GRSG ad hoc working group on the safety of wheelchair passengers in road vehicles
Working document following the 3rd meeting in Madrid

Notes:

1. This proposal is based on TRANS/WP.29/GRSG/2003/5 and includes extracts from that document.
2. Amendments contained in TRANS/WP.29/GRSG/2003/22/Rev.1, TRANS/WP.29/GRSG/2004/9, TRANS/WP.29/GRSG/2004/9/Corr.1, and those agreed at the last GRSG meeting are marked in *italics*.
3. All proposed new text is marked **bold** and deleted text ~~striketrough~~.

Fig. A8/1
Paragraph 3.11.4.1.7.1.

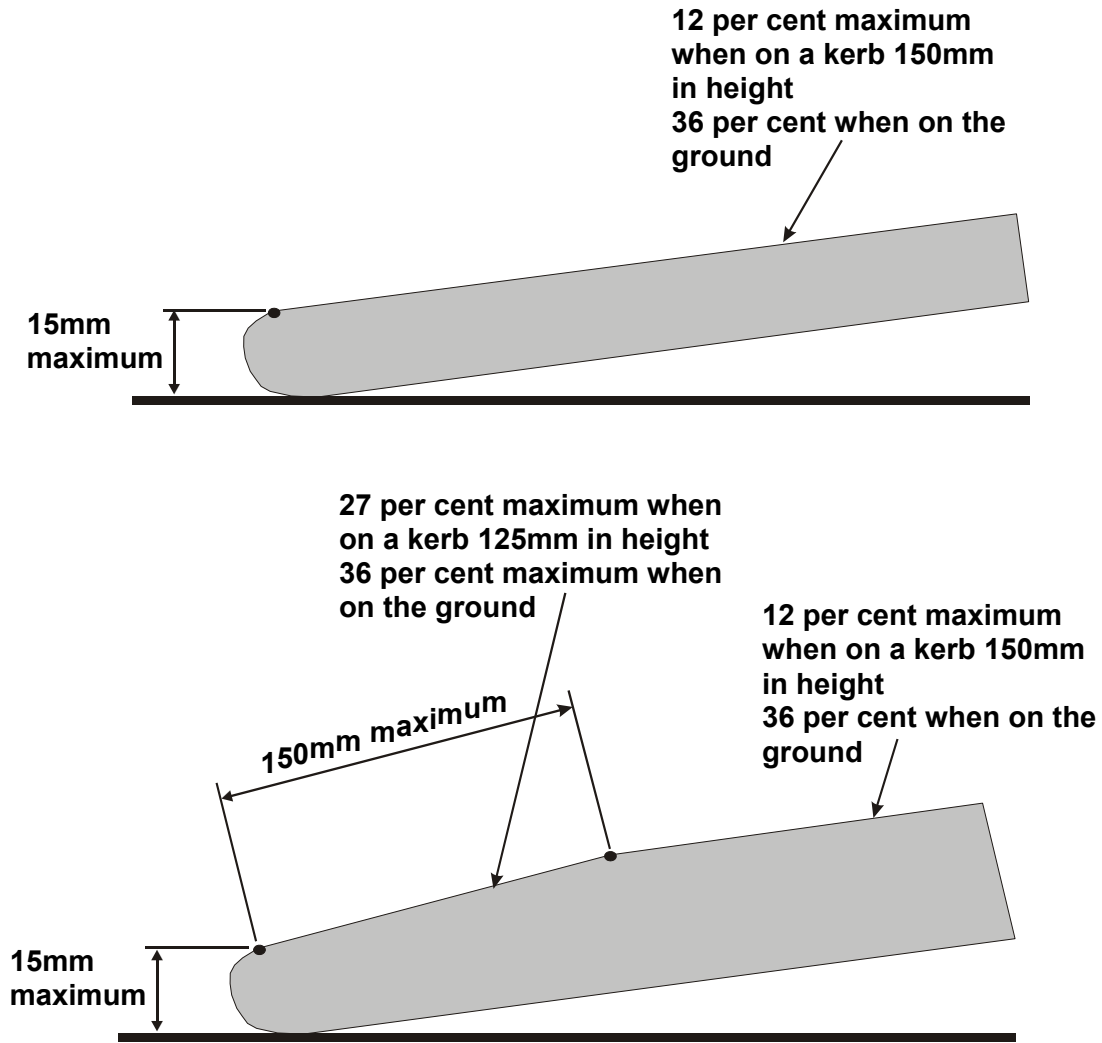
- 3.11.4.1.7.1. at the point where the ramp meets the kerb or ground it is possible to contact the main surface of the ramp or a transition section leading to the main surface as specified in 3.11.4.1.3. at or below a plane parallel to, and not exceeding 15mm in height measured above the surface of the kerb or the ground, This must be achieved with the ramp resting on a kerb 150mm in height and when resting on the ground. (see fig A8/1);**

Fig. A 8/4
Paragraph 3.8.4.

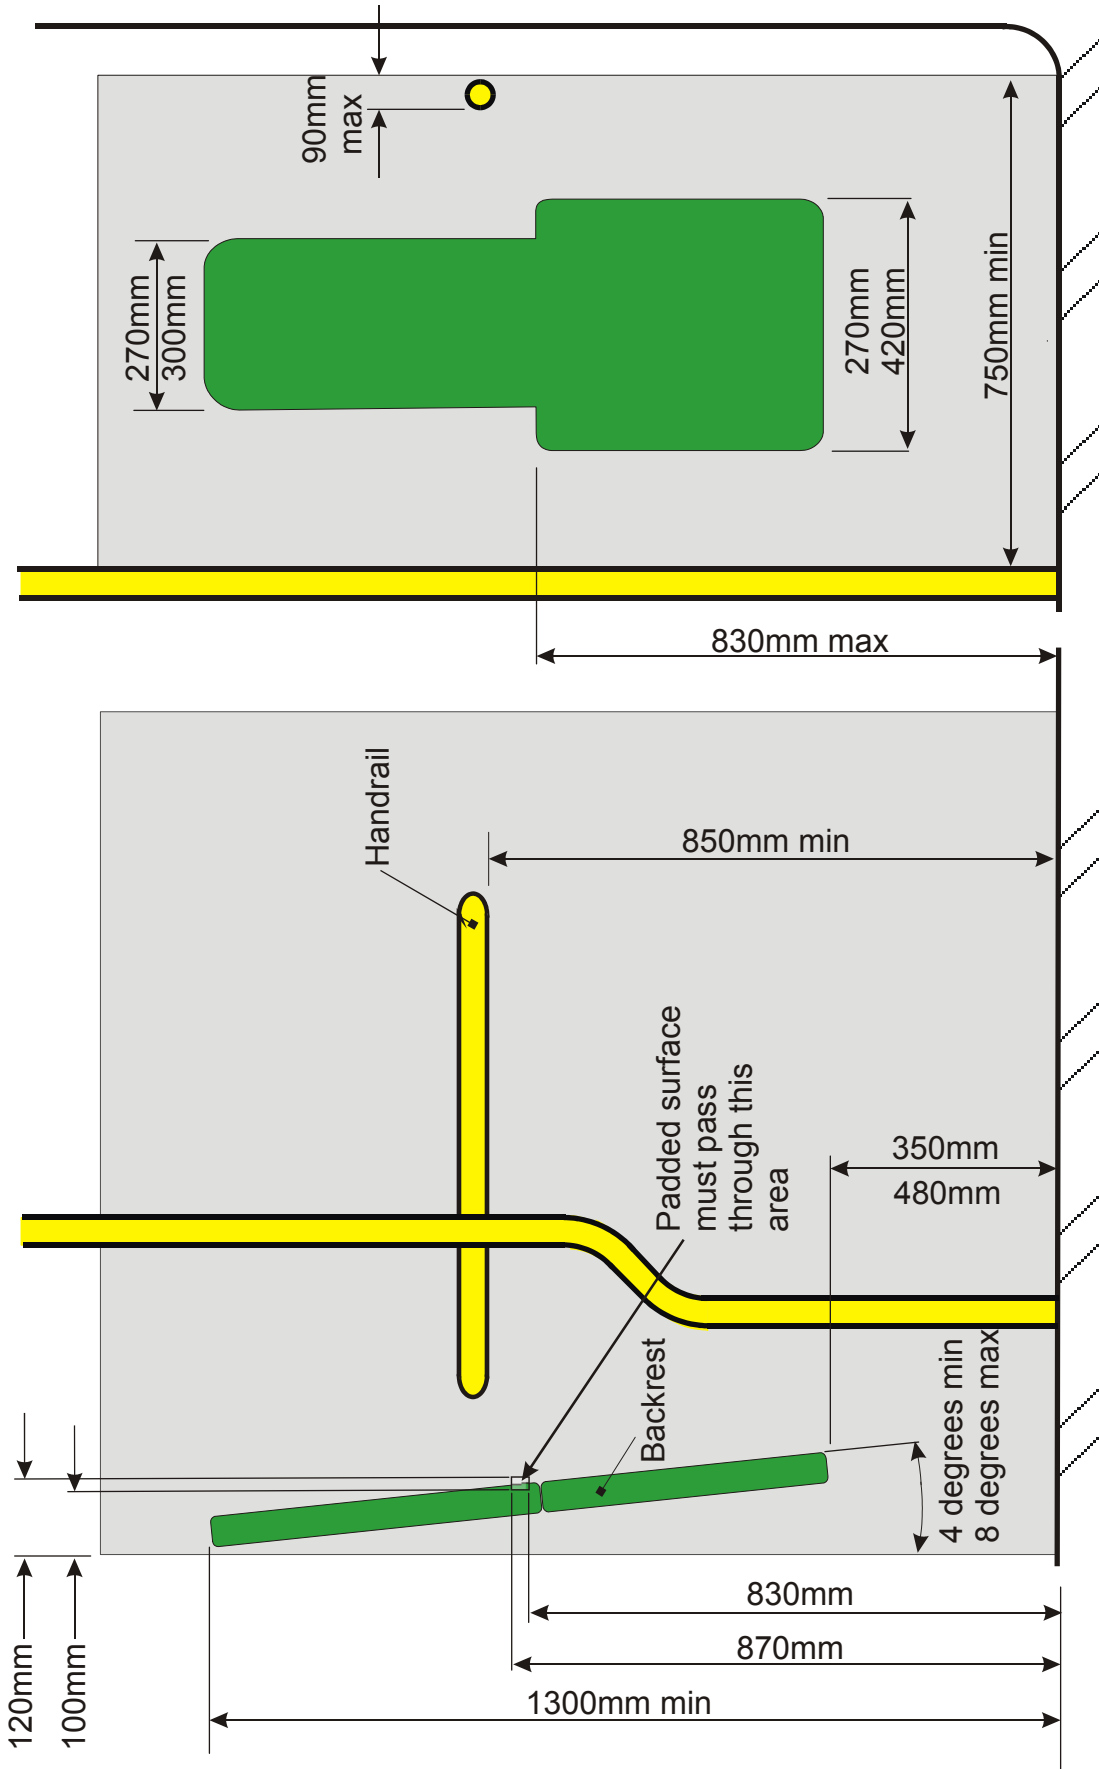
- (e) **the padded surface of a backrest shall form a single and continuous plane;**
- (f) **the padded surface of a backrest shall pass through any point on an imaginary vertical plane situated to the rear of the front end of the wheelchair space and situated not less than 100 mm and not more than 120 mm from the front end of the wheelchair space measured horizontally and not less than 830 mm and not more than 870 mm from the floor of the wheelchair space measured vertically; and**

- (g) **a backrest shall be capable of bearing a load of 250 daN ± 20 daN applied for a minimum of 1.5 seconds by means of a block 200 mm x 200 mm square in the longitudinal plane of the vehicle towards the front of the vehicle to the centre of the padded surface of the backrest at a height of not less than 600 mm and not more than 800 mm measured vertically from the floor of the wheelchair space. The**

- (h) A support, not being a backrest meeting the requirements of 3.8.4.1. above shall be proven to provide comparable levels of protection as such a backrest. It shall be able to withstand a force of 250daN ± 20daN per wheelchair applied in the horizontal plane of the vehicle and towards the front of the vehicle in the middle of the support. The force shall be maintained for a period of not less than 1.5 seconds.**

The position, shape and method of testing the backrest is added to ensure that it suits a wide range of wheelchair designs and provides adequate protection to a wheelchair user. Provision is made for an alternative means of support if it can offer an equivalent level of protection.
